2019 ELLINGTON APARTMENT

2019 ELLINGTON STREET
BUILDING A
HOUSTON, TEXAS 77088

FLOOR PLANS & NOTES

A2.00
OF

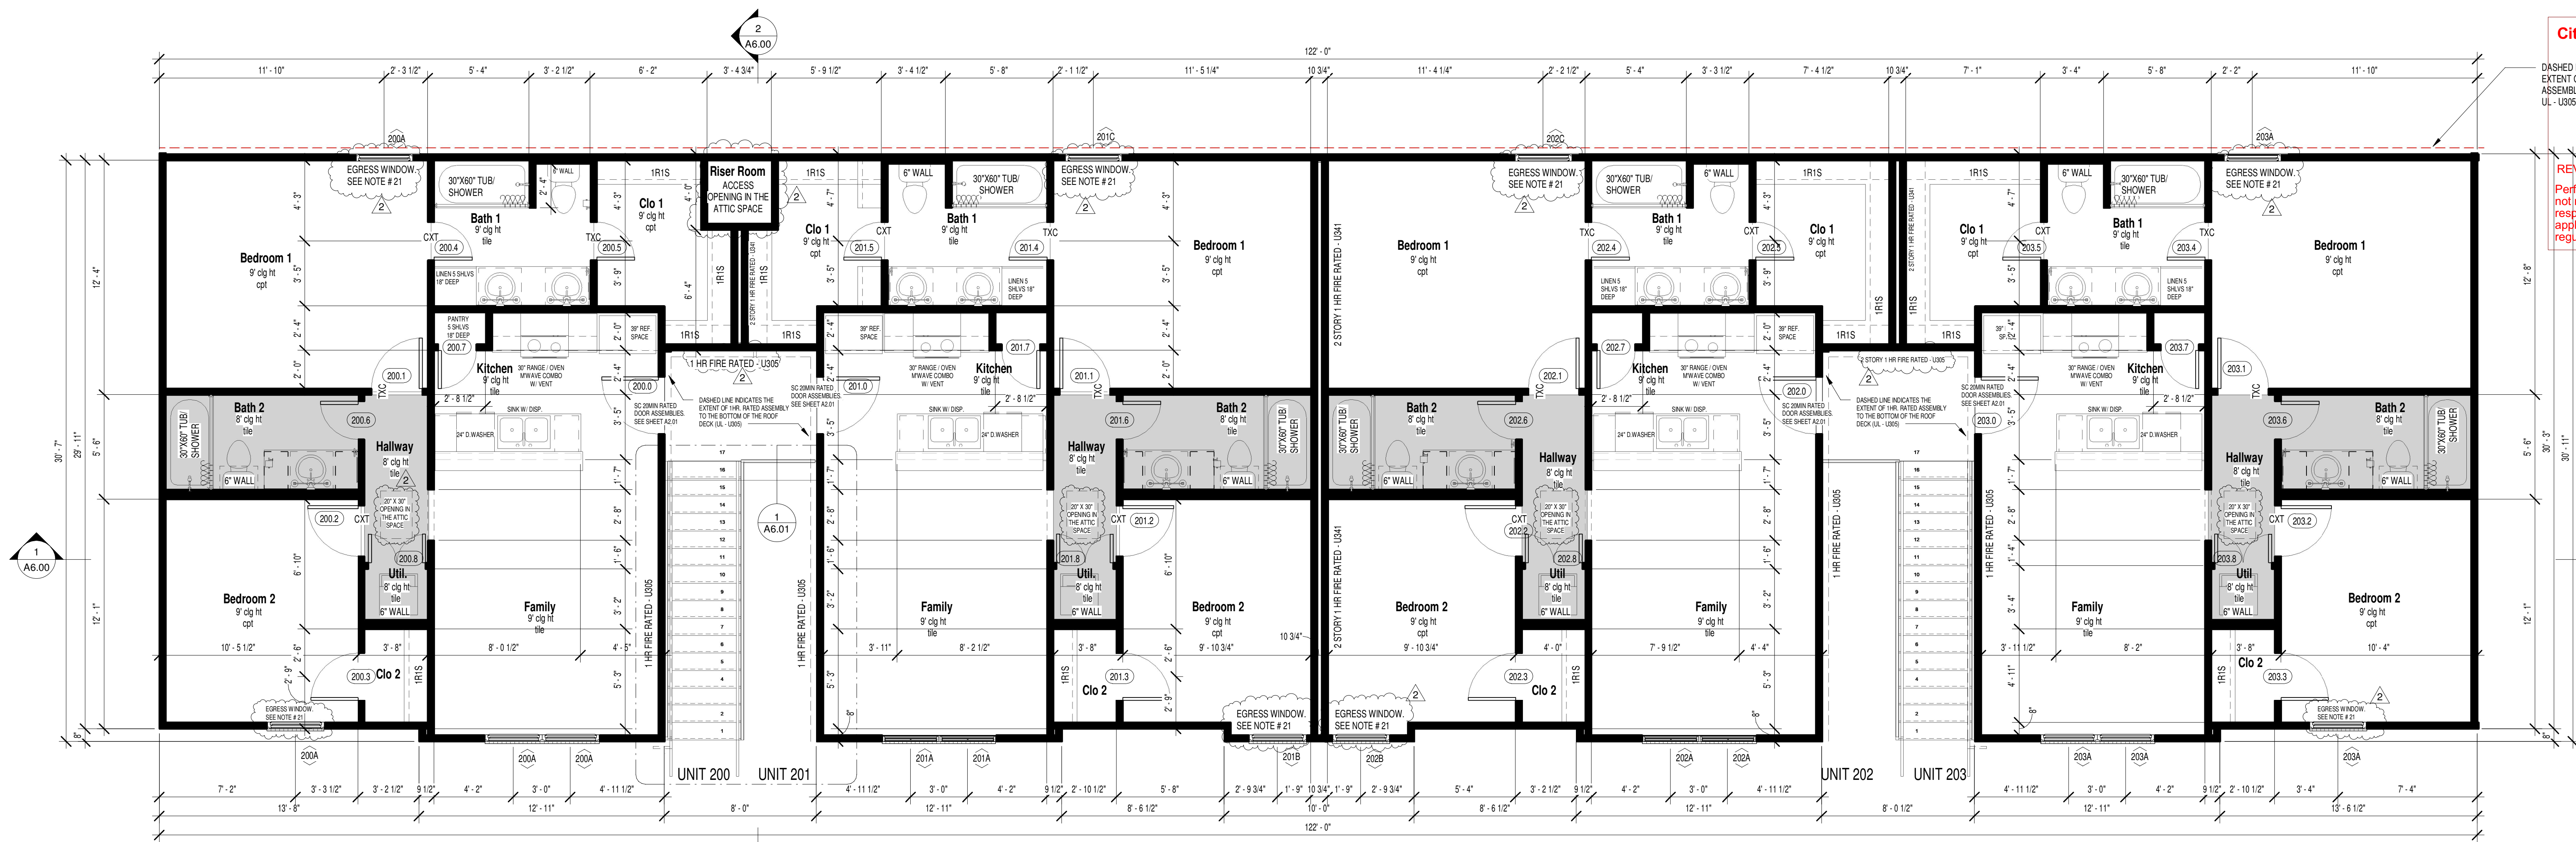
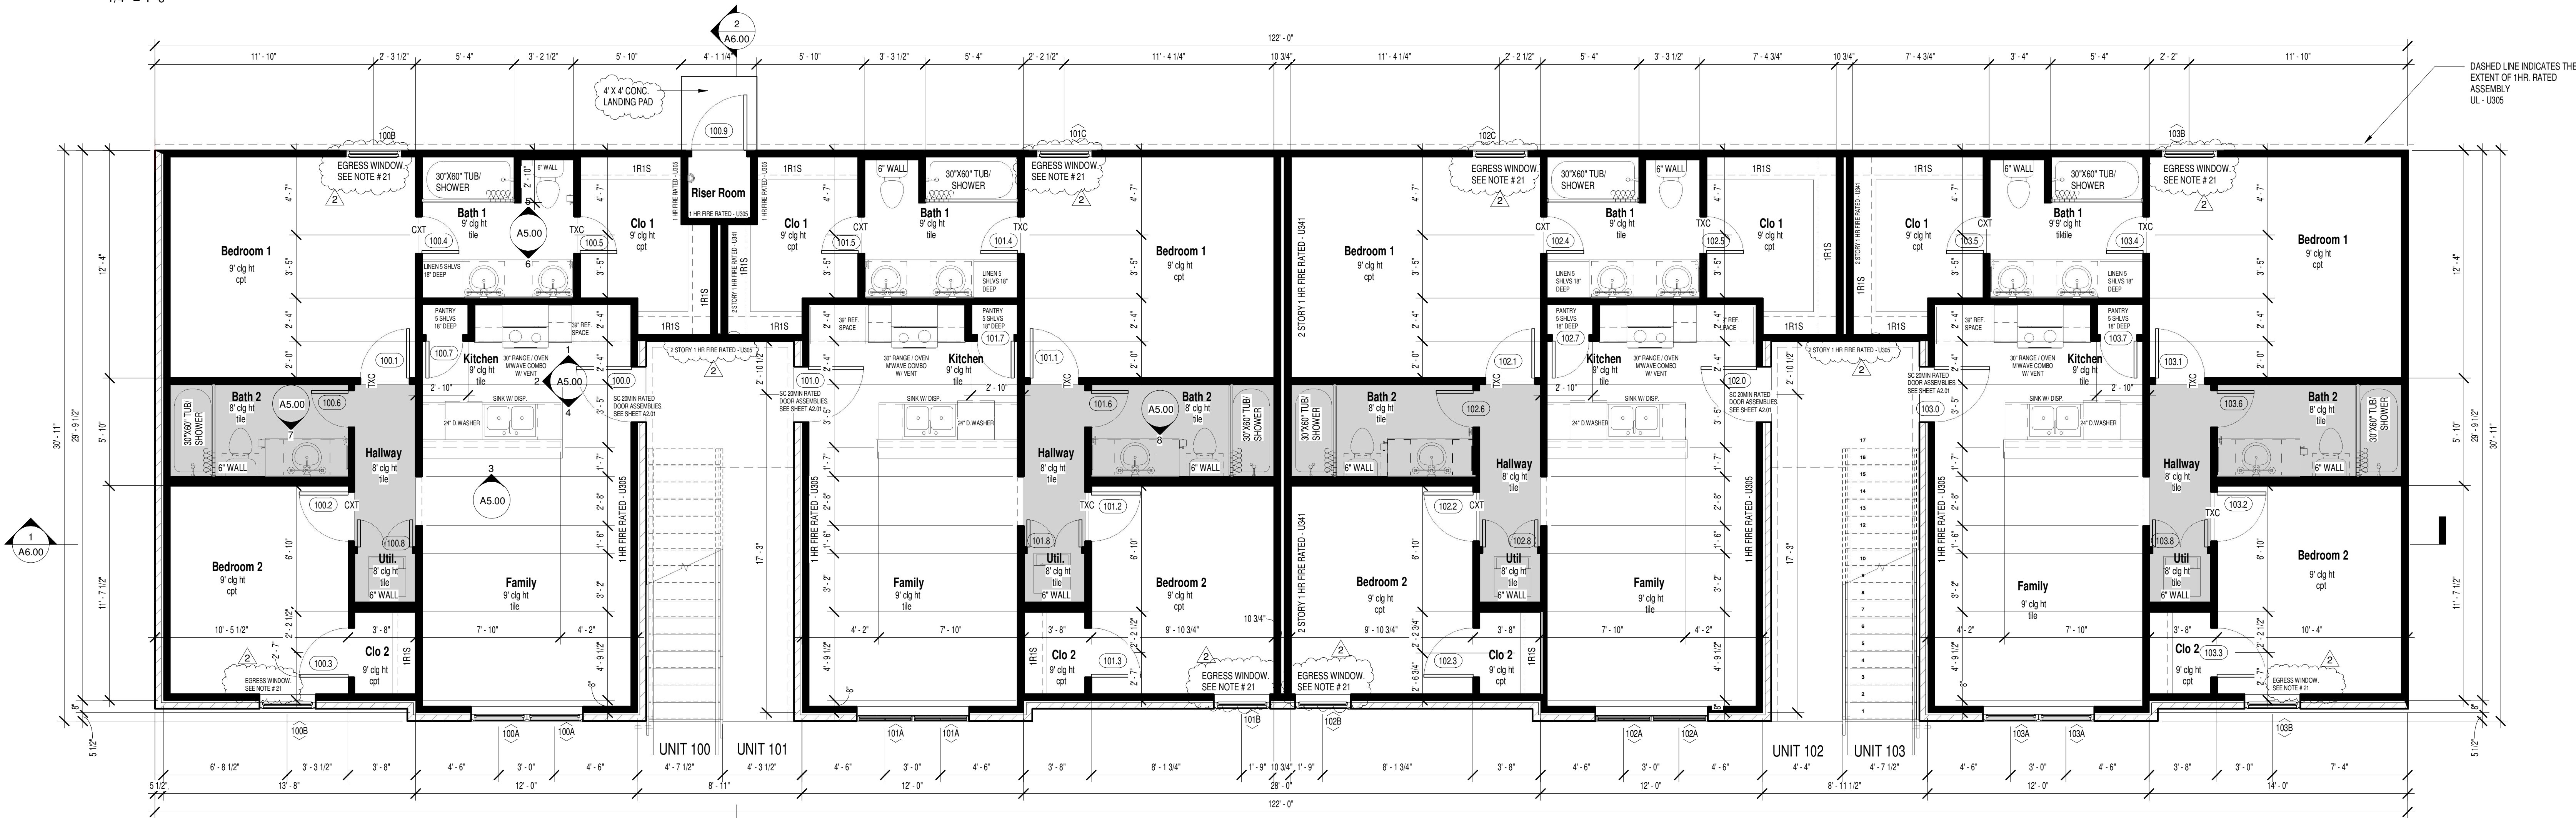
where on the plan?
